ILMEEYAT APPARELS LIMITED (New Building 3)

28 December 2023

2. Observations:

Observation-1: Mismatch in as-built drawing. (Substation & Generator Building)

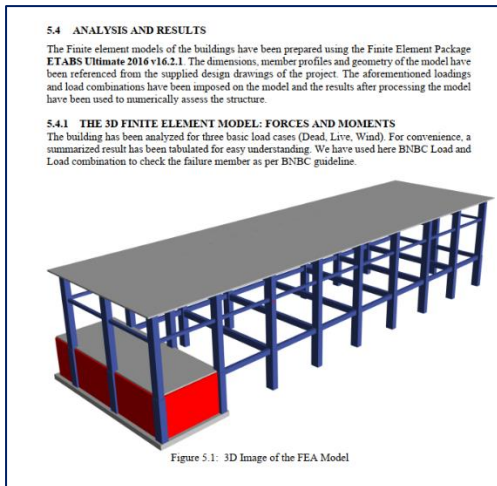
Description: Lintel/tie beam layout does not match with as-built condition. Mismatches are shown in red on the layout. The building engineer is required to update the as-built drawing correcting the tie-beam layout and submitting it to RSC.

Observation-3: Apparently non-engineered & undocumented connection bridge and external steel stair. (Substation & Generator Building; Boiler & Compressor Building)

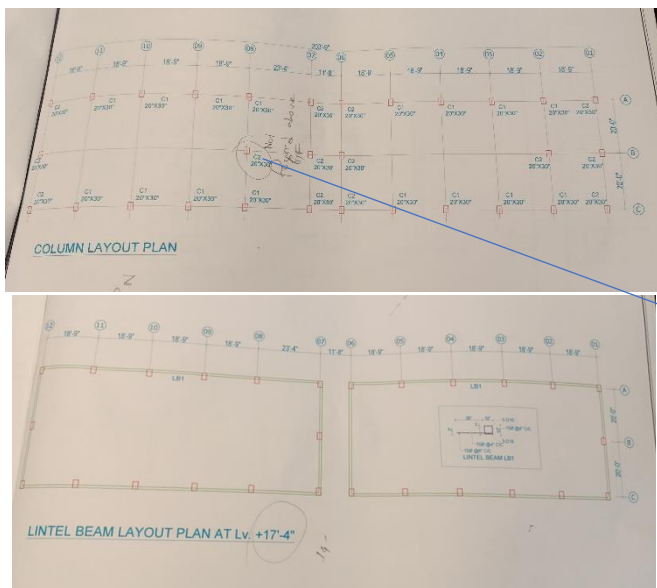
Description: Undocumented external steel stair and connection bridge were found in between of these building. The steel stair/ladder and connection bridge seem to be non-engineered. The building engineer is required replace the steel stair and connection bridge with an engineered one.

Observation-4: Discrepancies in as-built drawing. (Boiler & Compressor Building)

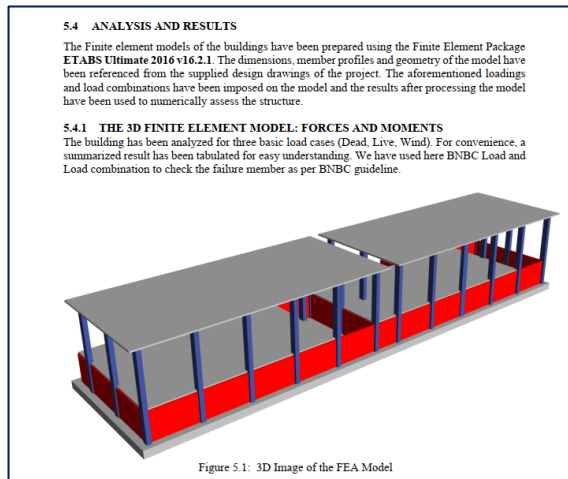
Description: C-2 type column on grid 08 does not found above the ground floor. Also, the lintel level was found at +4.3 m level from plinth instead of 5.2 m. The building engineer is required to update the as-built drawing correcting the tie-beam layout and submitting it to RSC.
